Teen Age Modern Fashion – Extension

Purbohati, Hemayetpur, Savar, Dhaka-1340.

05 September 2023

Floor layout

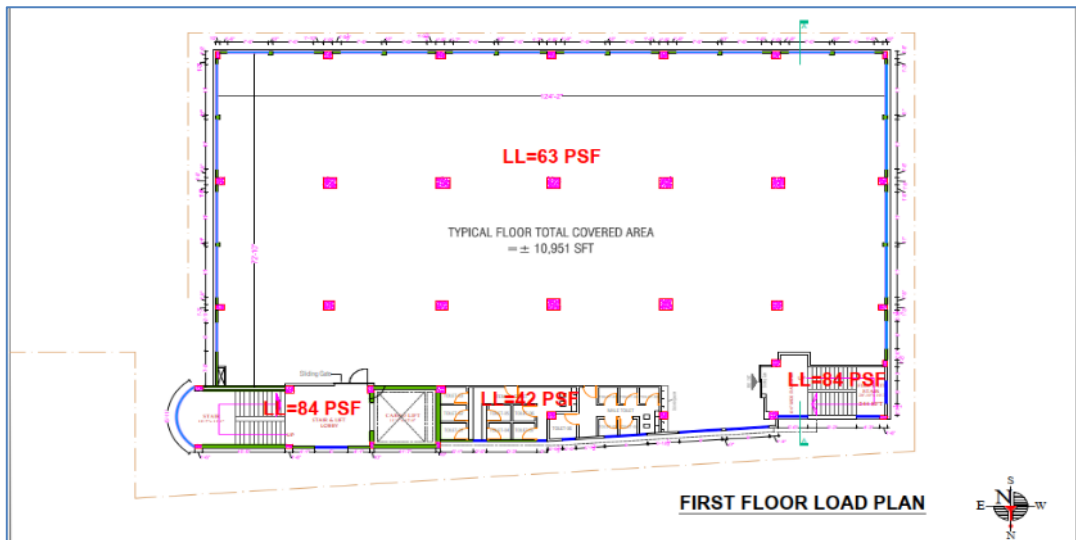
Mismatches in as built drawings

Undocumented water tank

Roof layout not found in the provided as-built drawings. Undocumented plastic water tanks were found on the roof. Moreover, toilet zone of 1st and 5th floor not matched with the provided floor layout. Building engineer is required to revise the as-built drawing as per onsite condition and submit to RSC.

Fire Command & Pump Room

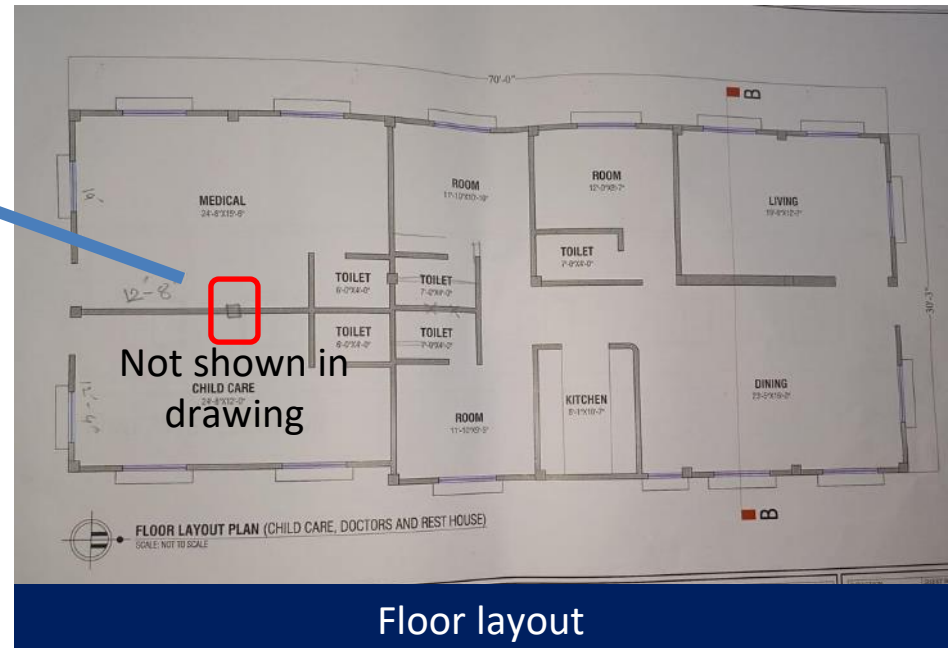
Lack of design report and as-built drawing

As per BNBC, every building or structure designed shall have its design documents prepared in accordance with the provision of Section 1.9.1. The design document shall include a design report, and a set of structural drawings, which shall be prepared in compliance with section 1.9.1.1 and section 1.9.1.2, part-6 of BNBC. At the time of inspection, no design report and as-built drawing was available which are required to be prepared in compliance with section 1.9.1.1 (part-6, BNBC).

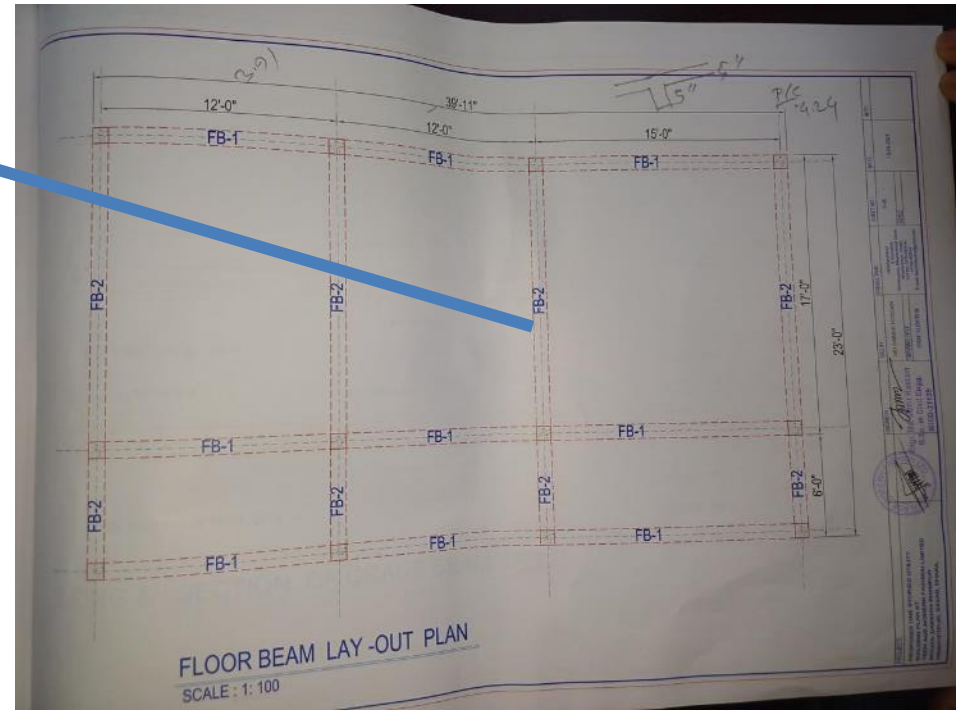
Inconsistencies in as built drawings

Slab details not found in the provided as-built drawings. Also brick column layout not matched with the as-built condition. Factory engineer is required to revise the as-built drawing as per onsite condition and submit to RSC.

Beam dimension in drawing

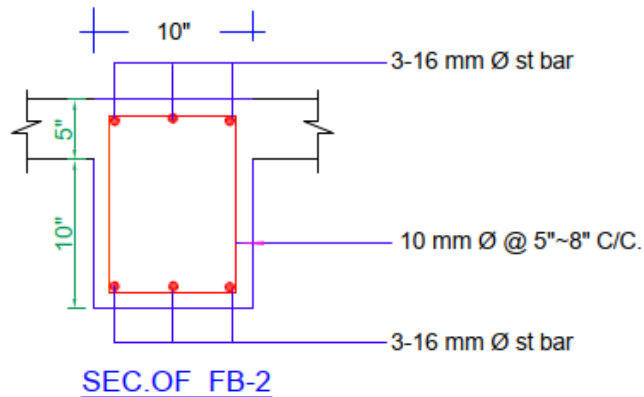
Beam size mismatch in drawings

Beam sizes are not matched with the provided as-built drawings. As per drawings the down stand of the beam is shown 250 mm (10 inch). But onsite down stand was found 125 mm (5 inch). Building engineer is required to revise the as-built drawing as per onsite condition and submit to RSC.

Truss frame

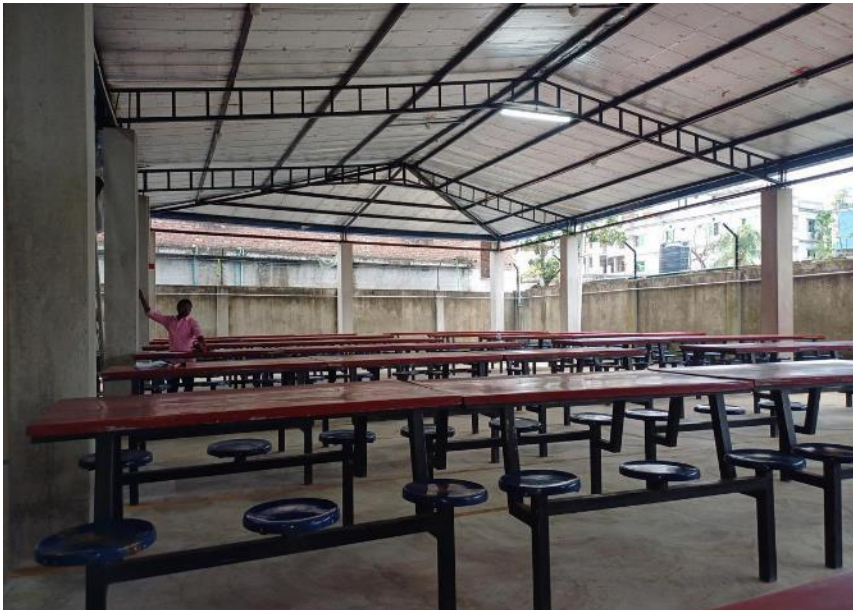
Apparently non-engineered connection

Apparently inadequate connections were observed at the lightweight roof of the single storied Sheds. The building engineer to check the connection adequacy of the lightweight roof against the uplift pressure of wind.

Worker Dining

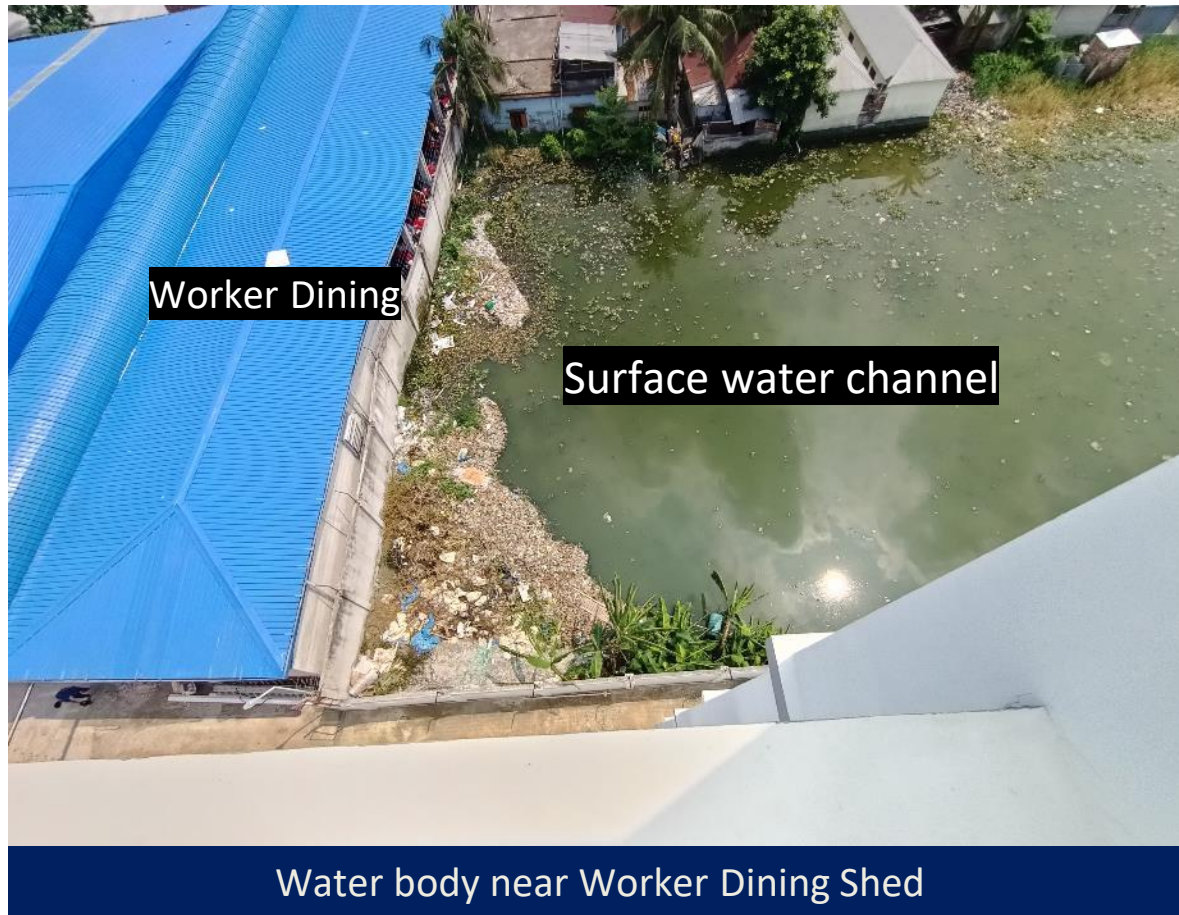
Lack of drawings (structural & architectural)

Structural and architectural drawings were not found for the Worker Dining. Only a column layout was provided for the structure which was not matched with on-site condition. The factory engineer is required to survey the whole structure and prepare full set of as-built drawing in compliance in compliance with section 1.9.1.2, part-6 of BNBC.

Framing of the structure

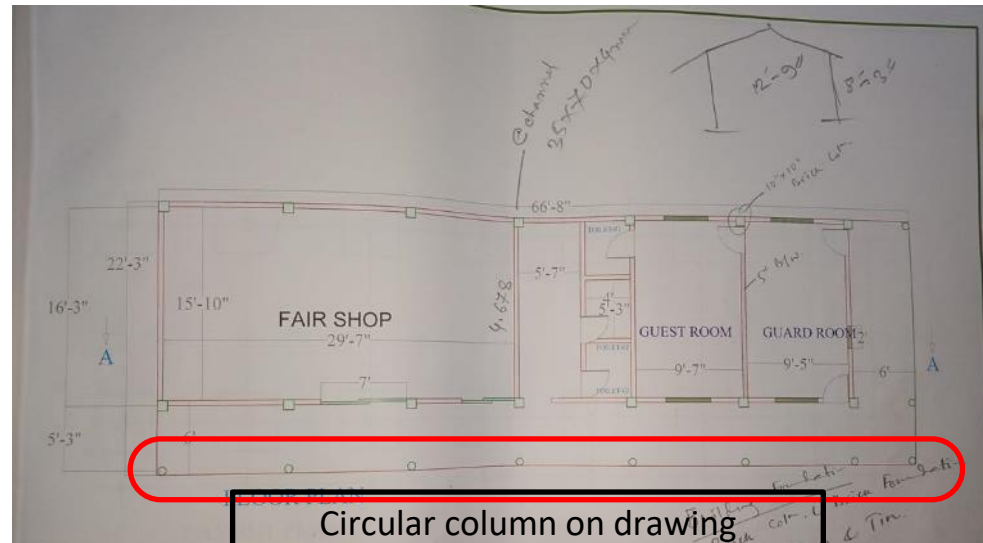
Incomplete in as built drawings

Framing and connection details not found in the provided as built drawings. Moreover, circular columns are shown in the drawings, but on-site square brick columns were found. The factory engineer is required to survey the whole structure and prepare full set of as-built drawing in compliance in compliance with section 1.9.1.2, part-6 of BNBC.

Truss connection with RC column

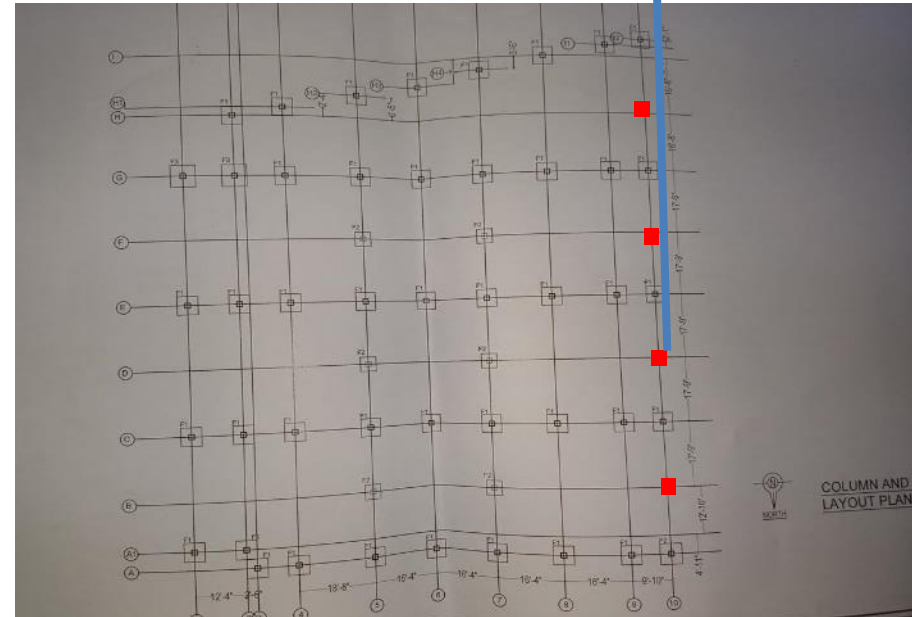
Lack of information in design documents

Connection details were not found in the drawings. Provided connection details were incomplete and not fully match with as-built condition. Moreover, additional RC column were found on end grid. No foundations details were found for those column. The Factory engineer required to revise the as-built drawings as per on-site condition. Also, check the connection adequacy of the frame and load path & structural integrity for the additional column.
